Product Change Notice (PCN)

Subject: Addition of production sites for RL78/G11(16pin), G1P, I1D, G1A.

**Difference of specification
(RL78 family HWQFN products)
3mm×3mm 0.5mm pitch 16pin
4mm×4mm 0.5mm pitch 24pin
5mm×5mm 0.5mm pitch 32pin**

MCP-AB-22-0089

Packing specification for Tape & Reel

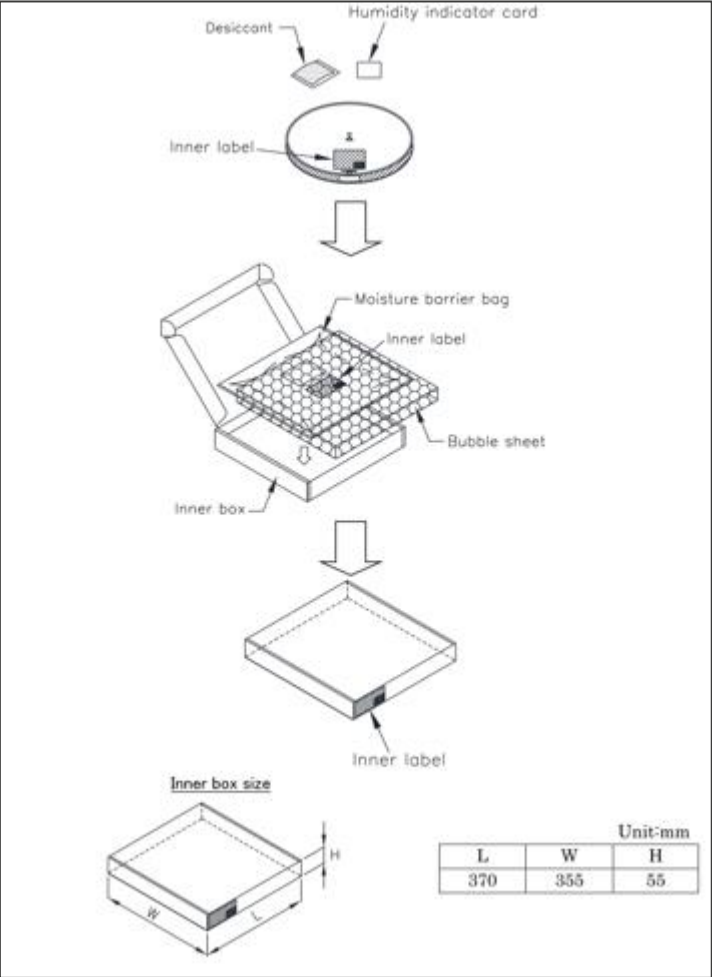
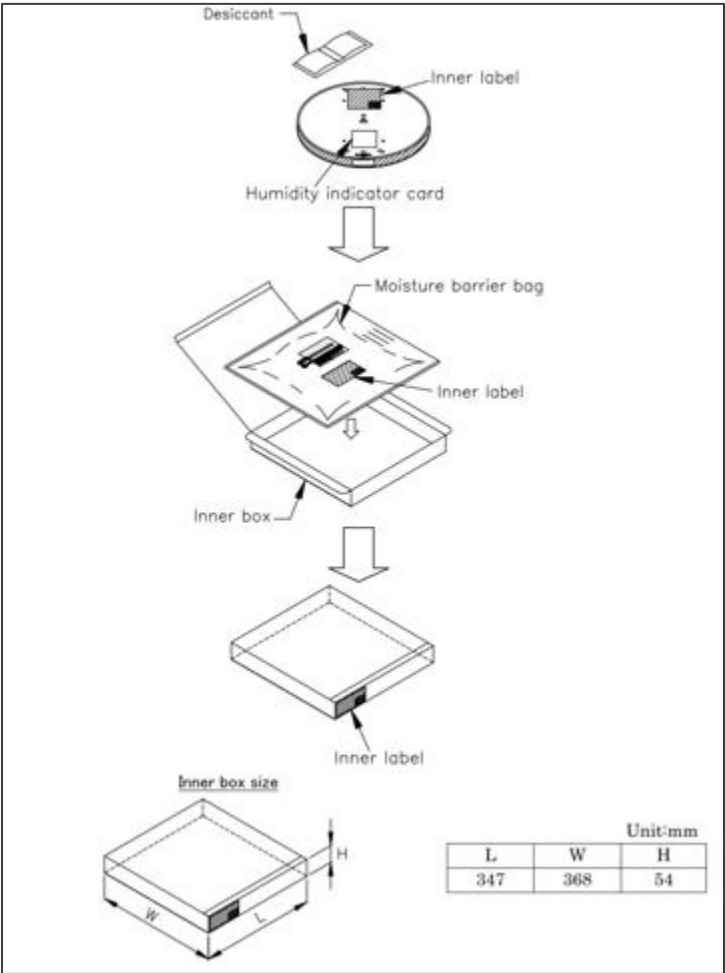
Packing material	Tape & Reel	
	Additional (UTAC)	Existing (KYEC)
Moisture barrier bag *Refer to page 18 for printed characters.	<p>•Size : 406.4mm×457.2mm</p> 	<p>•Size : 415mm×500mm</p> 
Inner box	<p>•Size : 370mm×355mm×55mm</p> 	<p>•Size : 347mm×368mm×54mm</p> 
Desiccant	<p>•Weight : 33g</p> 	<p>•Weight : 25g+25g</p>
